Richmond Hill Campus

Addendum to Stage 3 Report

Document no. 1399-INT-ZZ-ZZ-RP-S-0004

Date	Suitability	Revision	Comments
10 May 2024	S1	P01	First Issue
28 Aug 2024	S2	P02	Section 2.2 added

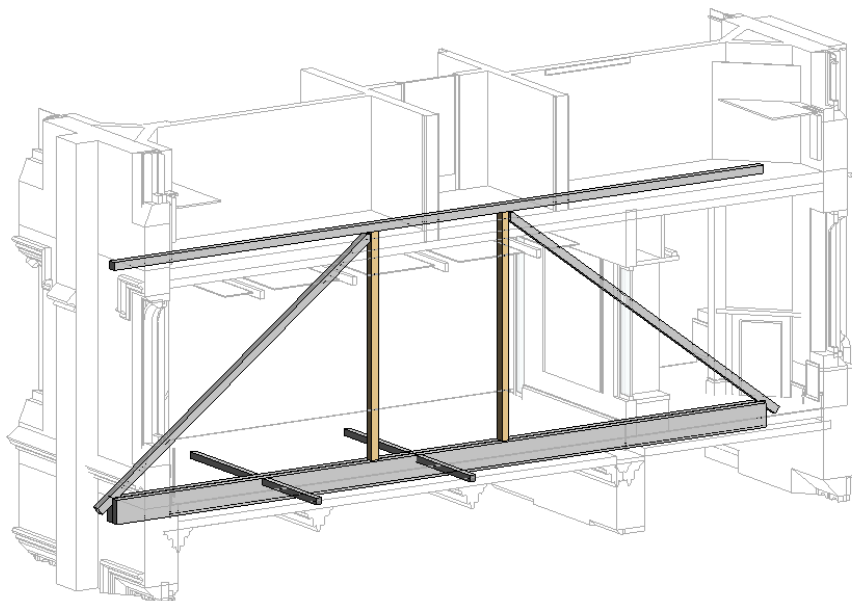
Input from contractors has been sought on the temporary works design to the wing alterations. Option A as laid out in the Stage 3 report is to be adopted by the contractor. This option limits the impact on the existing building fabric.

Existing condition

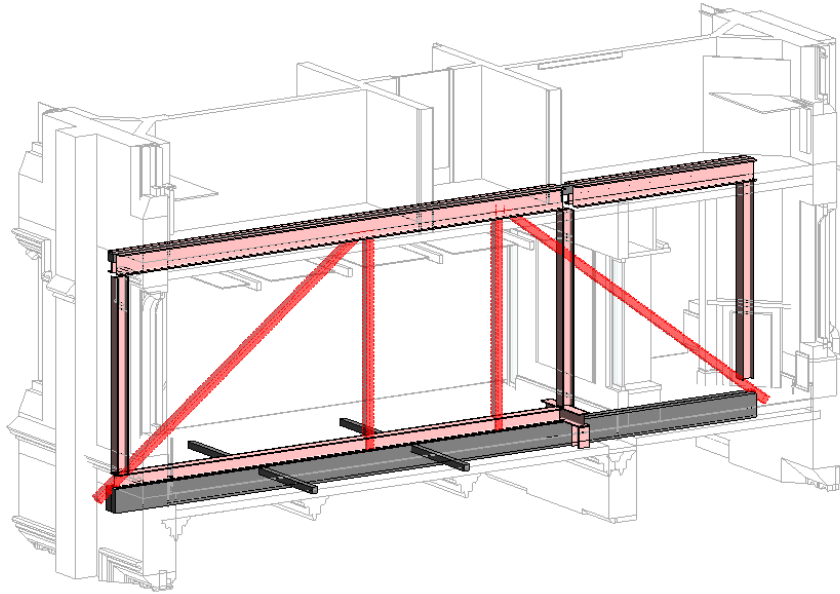
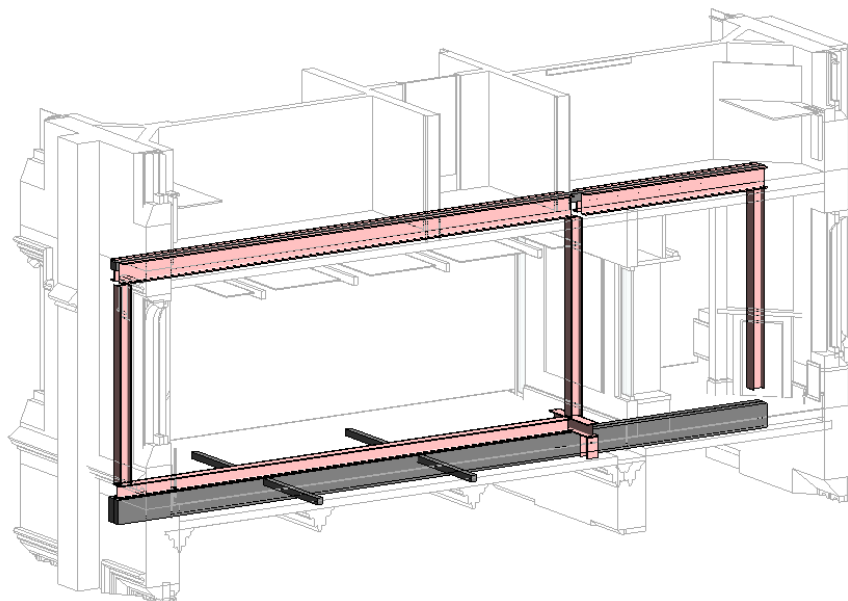
Opening up works to confirm structural elements has been undertaken since the Stage 3 report was written. This has revealed that the partitions to the 2nd floor of the main building are acting as trusses.

A design has been developed to allow the removal of the stud walls and the struts within. This requires the propping of the existing floors. Once propped the struts are to be removed and new steel installed.

To the 2nd floor the strengthening is to be installed from above the existing timber beams. At 3rd floor the strengthening is simply installed to the underside of the floors.

Details of proposed strengthening

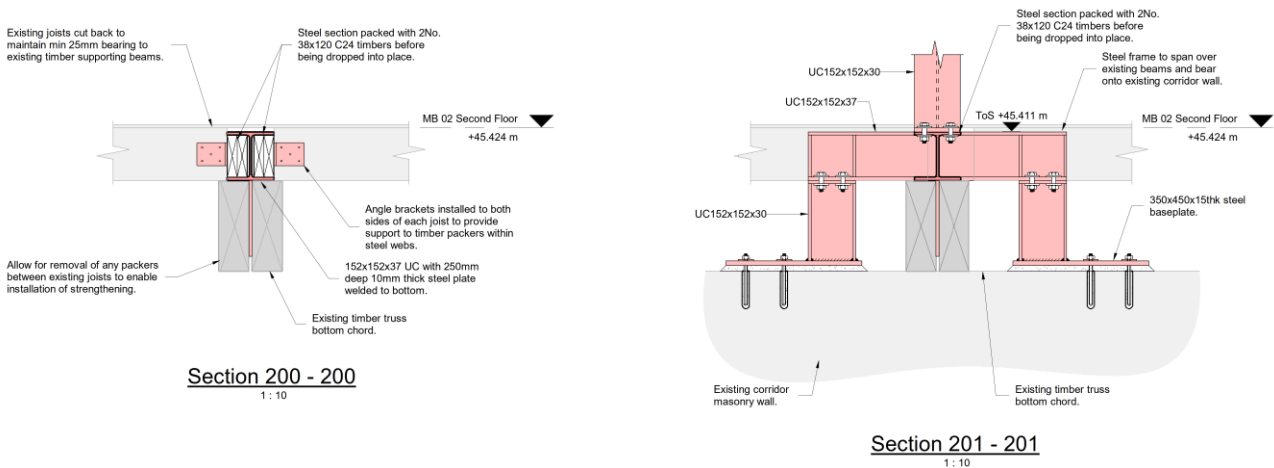
The connection details have been developed to ensure that the load transfer between the existing joists can be maintained and the plaster moulding retained. To prevent crushing of the timber at the bearing a transfer frame has been designed to allow the load to pass into the masonry wall below.

Existing mezzanine floor, at first floor level

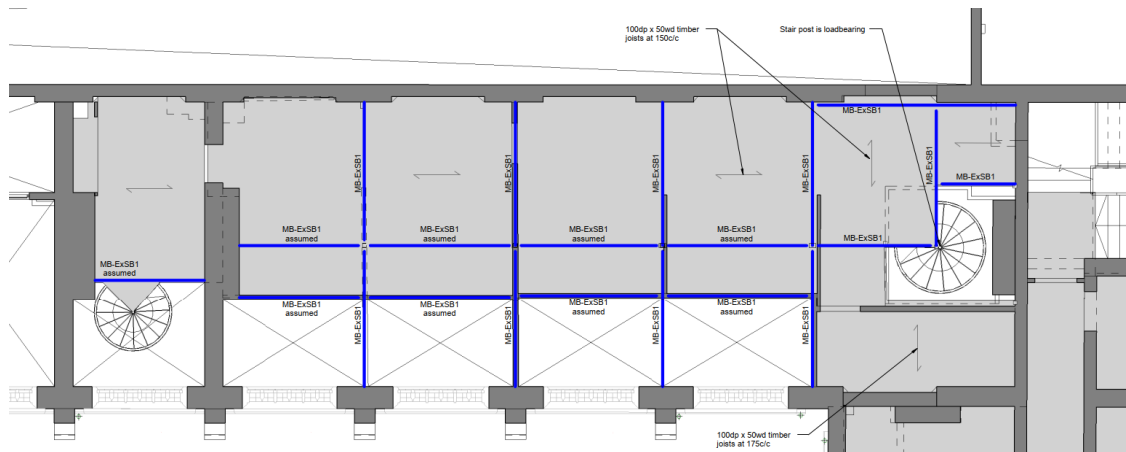
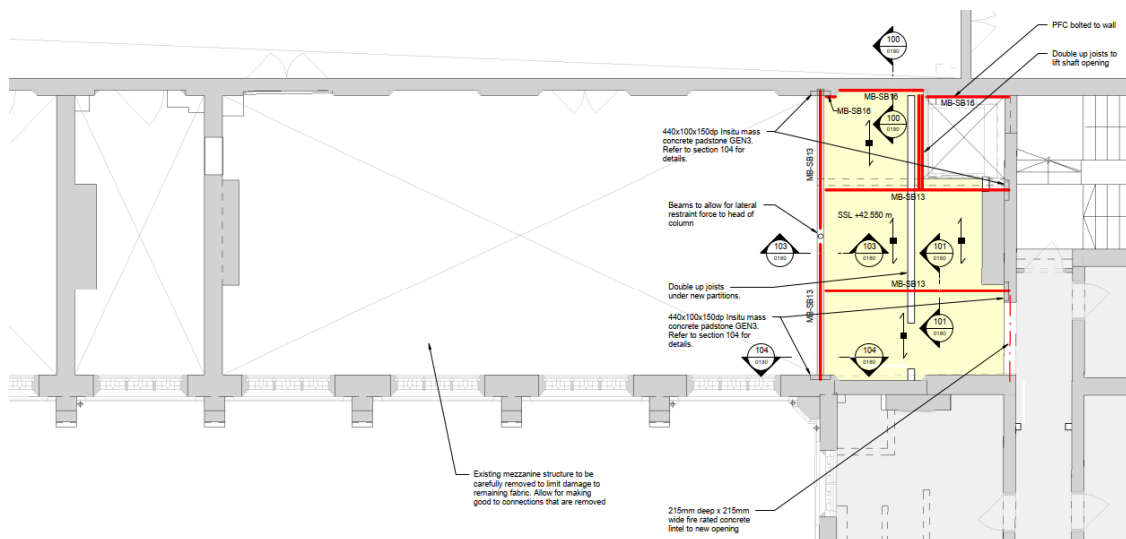
At first floor level, a mezzanine floor was added to the main building in 1989 and is to be removed as part of the proposed works. A small area to the north of building is to be reinstated where the existing mezzanine is considered not adequate.

Proposed connection of new mezzanine column to existing ground floor beams

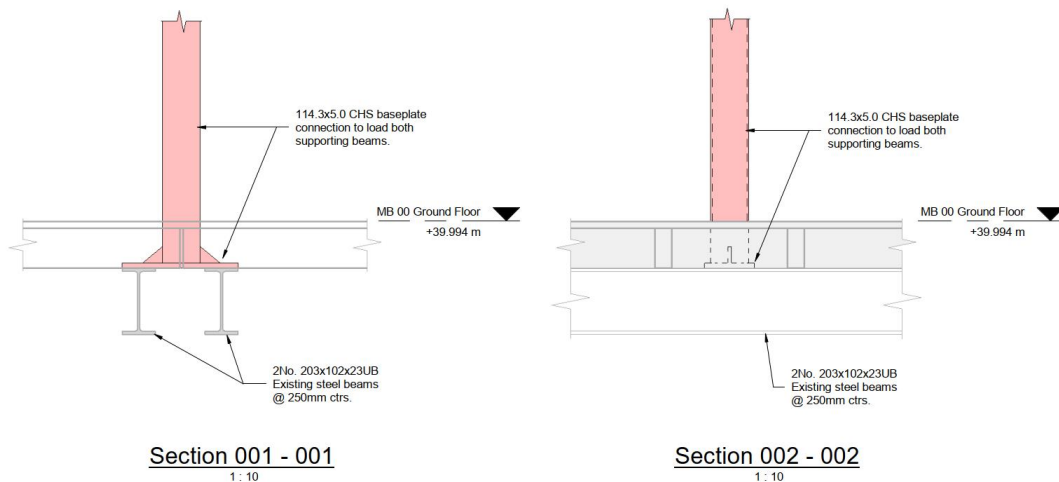
A CHS column supports the proposed mezzanine at midspan along its perimeter. The column is supported on existing steel beams within the ground floor. Here, and elsewhere, the load of the reinstated mezzanine on the existing structure has been checked for the altered load paths, and the capacity of the existing structure is suitable in the proposed condition.

Section through proposed moment frames with propping indicated

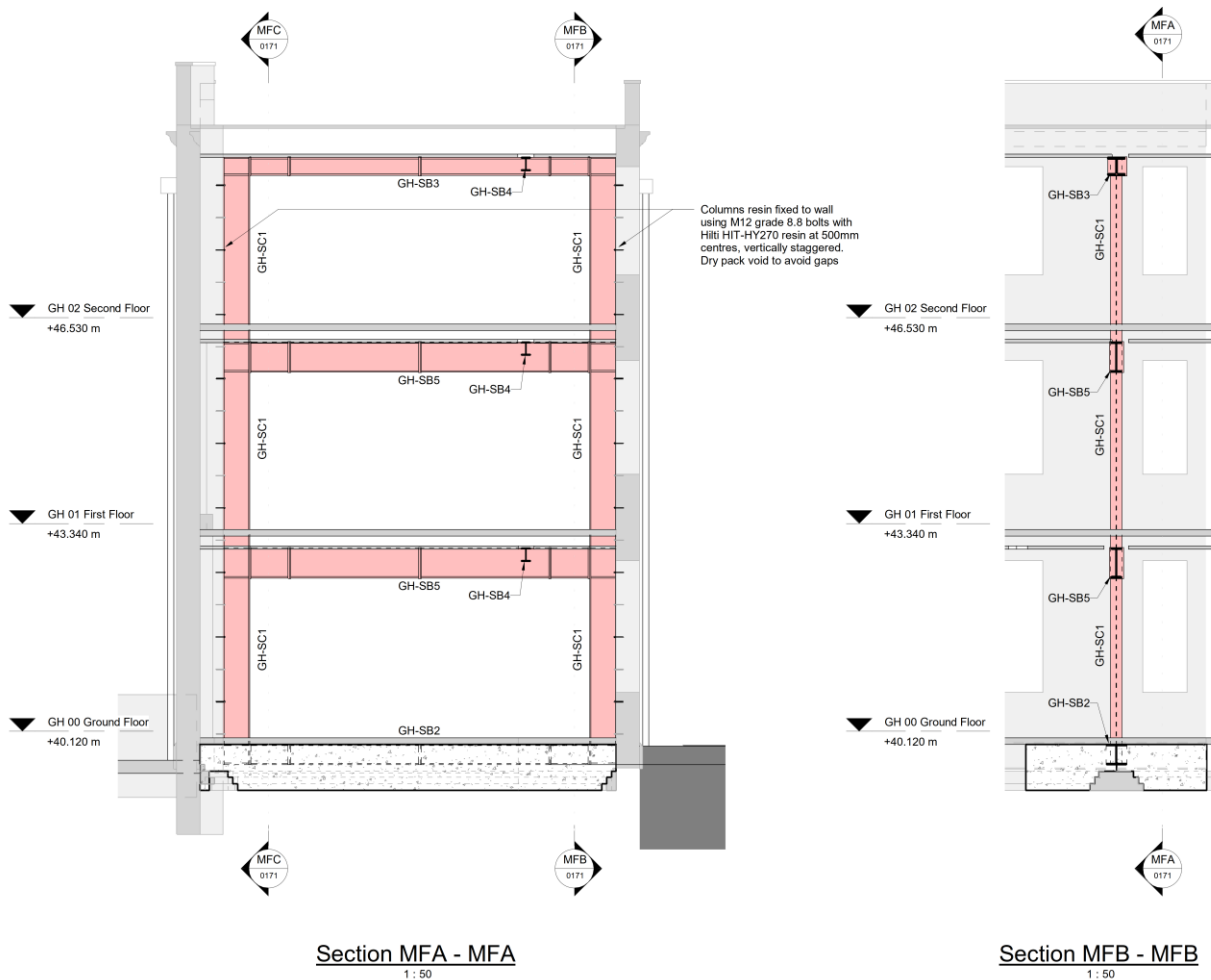
The temporary works for the wall removal and installation of the moment frame to George House is less complex than that of the main building wing works as there is no wall to remain on an upper level.

Once the slabs are propped and supported the walls can be removed and the new frames installed. Openings for columns to pass through floors are to be minimised to reduce the amount of infill required. Once dry packed the temporary propping can be removed and the load transfer is complete.

The slab will act as a diaphragm and temporarily distribute stability forces into the remaining walls. The moment frame restores the original load paths once the works are complete.

The size of the opening for the columns is to be agreed with the contractor. It is proposed these are kept as small as possible so that a new infill stitch can be cast to transfer load in the final condition.

3D view of proposed alterations

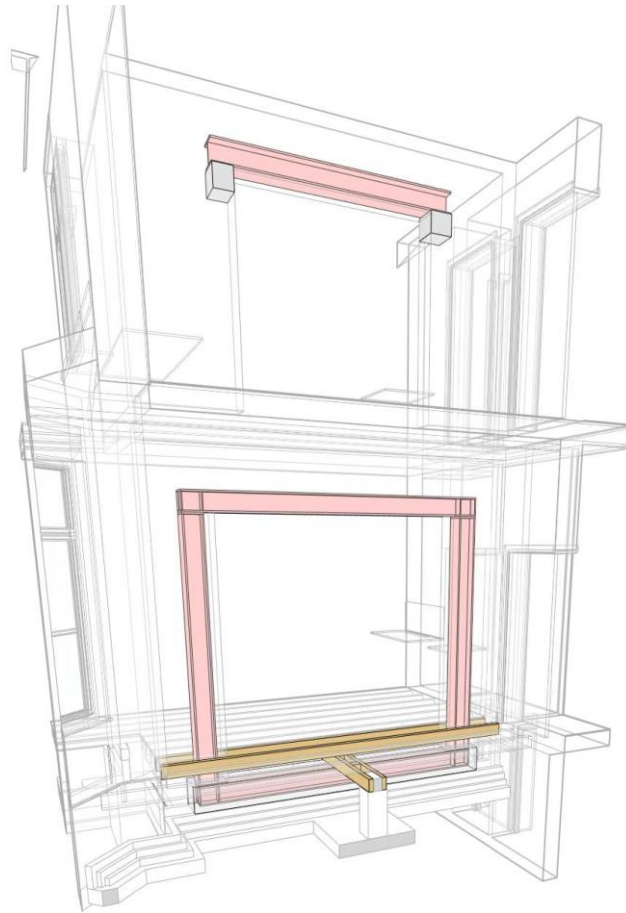
The design for the openings to Red House has developed to a reduced extent. At first floor the opening width has reduced and the remaining brick buttress can resist the applied wind loading. At ground floor a larger opening is required architecturally. To support the brick buttress at 1st floor and maintain original load paths this has been retained as a box frame. With the opening height reduced needle propping to the wall can occur below the 1st floor further reducing the impact of the alterations.
